Village of Bayside
Architectural Review Committee Meeting
March 11, 2019
Village Hall Board Room, 6:00 pm

**ARCHITECTURAL REVIEW COMMITTEE
AGENDA**

<p>PROJECT/SITE OWNER: Dondlinger Residence</p> <p>PROJECT ADDRESS: 1250 E Brown Deer Rd</p>	<p>PROJECT SUMMARY: New 6' spiral staircase off the existing back deck.</p>
--	---

<p>PROJECT/SITE OWNER: Kamm Residence</p> <p>PROJECT ADDRESS: 1434 E Brown Deer Rd</p>	<p>PROJECT SUMMARY: 2nd floor window replacement, 2x10 cedar eave/overhang, new patio style (same footprint), new outside siding (from horizontal to vertical with new material).</p>
--	--

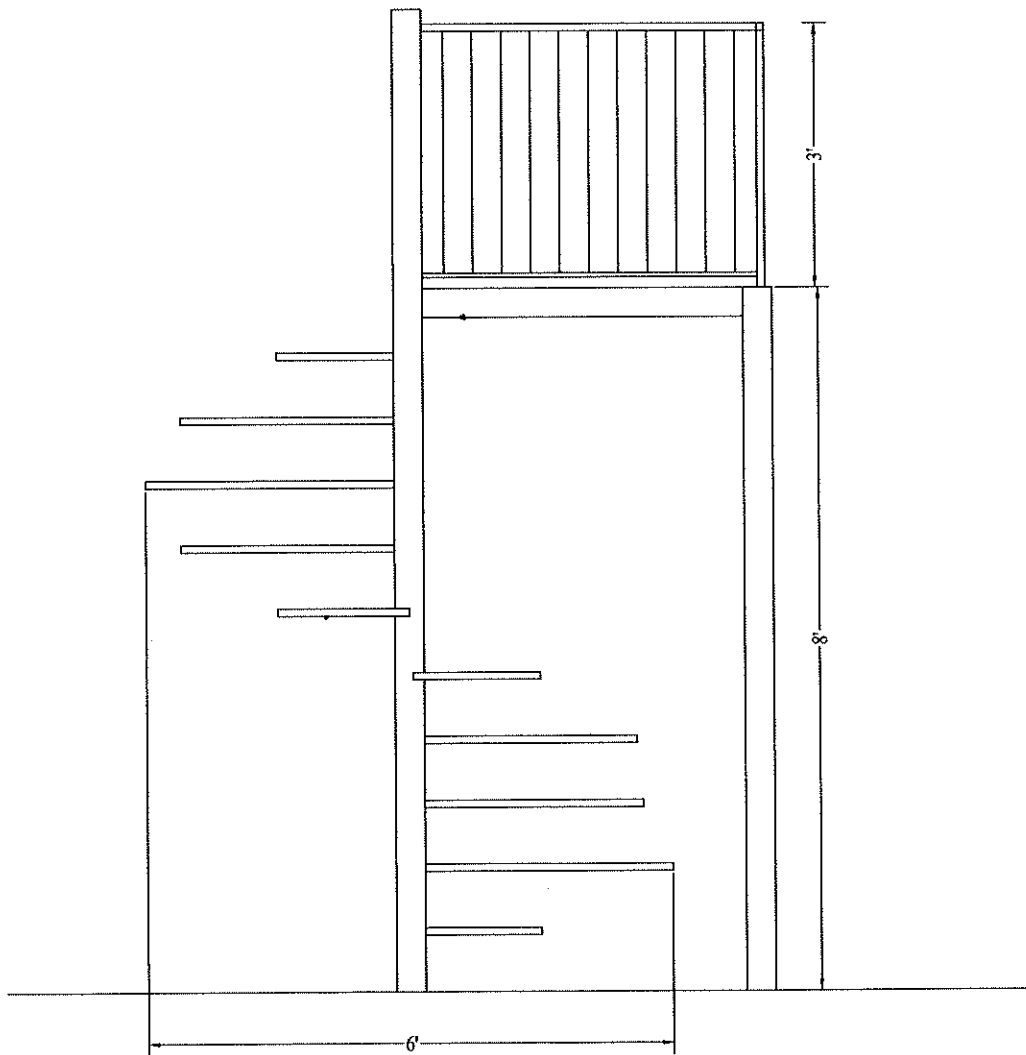
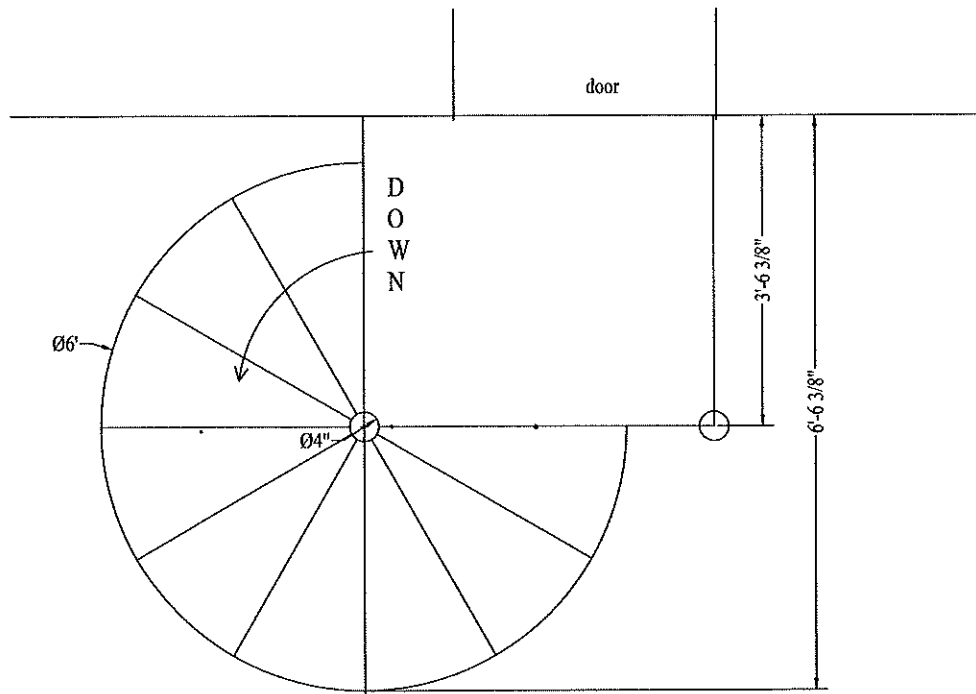
The balcony is to meet the requirements of SPS 321.03(8).

Proposed stair is not within the 10'-0" of the required setback for an accessory structure as indicated in 125-91(b)(5). Reviewer understands that the proposed location was approved by zoning.
